**"Design, Manufacture, Supply, Installation, Testing and Commissioning of Tunnel Ventilation System & Environmental Control System between Mumbai Central (excluding) to Cuffe Parade (including) Stations".
(Package: 15)**

Date: [16.01.2019]

Addendum No: 2

NAME	SIGN	PROJECT	STATION	DATE
DRAWN BY		MUMBAI METRO LINE 3 COLABA-BANDRA-SEEPZ		14-03-2018
DESIGN BY				
CHECKED BY		TITLE	DRAWING TITLE	SCALE
APPROVED BY		INTERFACE DRAWINGS	TUNNEL VENTILATION AND ENVIRONMENTAL CONTROL SYSTEM SCADA DRAWING	NTS (A1)
		DRAWING NO	GCC-TVE-PH2-001-041_A1

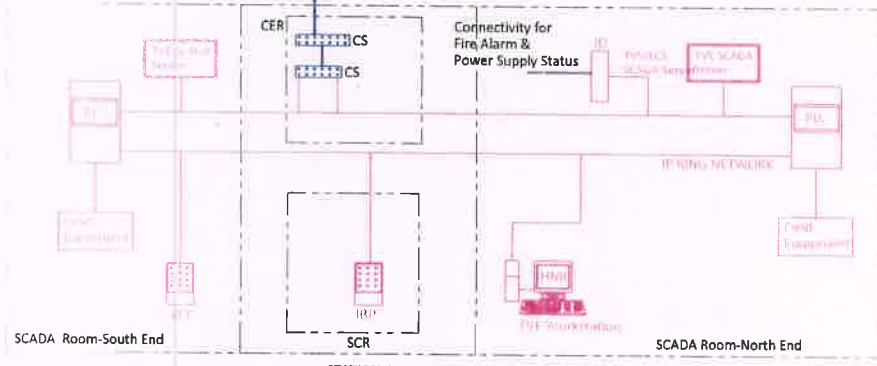
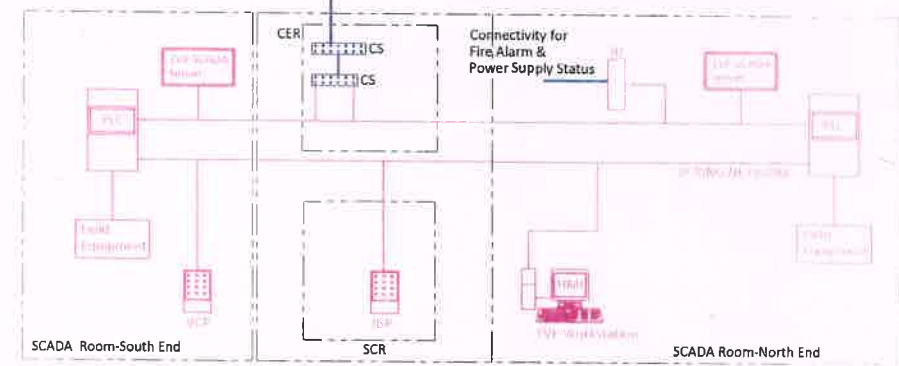
4	Part 4 - Drawings Section X - Drawings	<p>Replace : SCADA Drawing No.- GCC-TVE-P00-0001-041_A0</p> <p>With: SCADA Drawing No.- GCC-TVE-P00-0001-041_A1 Attachment No. 2 The scope delineation of Phase 1 vs. Phase 2 Lot1 and Lot 2 is shown</p>
5	Part 4 - Drawings Section X - Drawings	<p>Replace : Grant Road Station Drawings UGC-02-ARP-SGR-01001-002-A</p>

Note- OCC/BCC scope of work is under TVE-PH-1 contractor

REV	DATE	PREP	APPROVED	DESCRIPTION
1	10.12.18	AKB	NC	Scope of OCC/BCC work updated
